Informal document **GRE-70-41-Rev.1**
(70th GRE, 21-23 October 2013,
agenda item 4(b))

ECE/TRANS/WP.29/GRE/2013/57

**Alternative
aiming/leveling
(explanations)**

Tomasz Targosinski Ph. D. Eng
Poland
70 GRE 21-23 October 2013

Proposed Initial nominal aim to correspond to 75m theoretical range

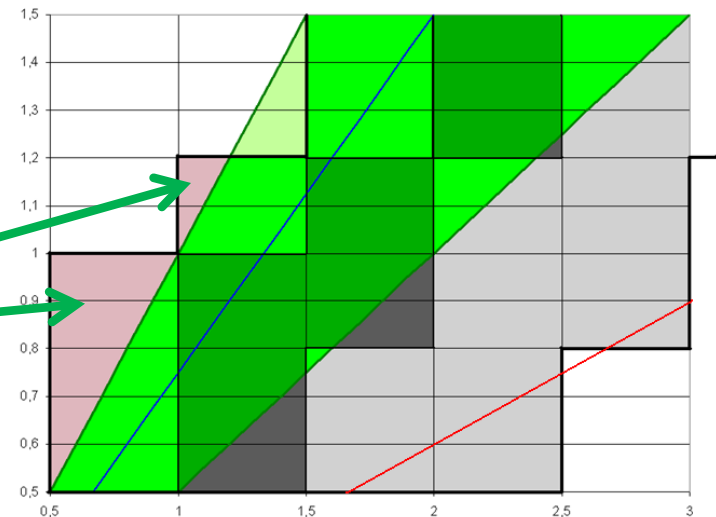
- Under proposal,
 - No overlap between height bands
 - Most headlamps would be aimed higher than at present

What for are needed overlaps?

- Risks increased glare.

It will depend on manufacturers decision and choice of range of amended Reg.48 (30 to 100m or 50 to 100m)

It will be safety oriented advantage and goal of amendment because of longer average road illumination distance.

Not true. Decreased glare comparing present state.
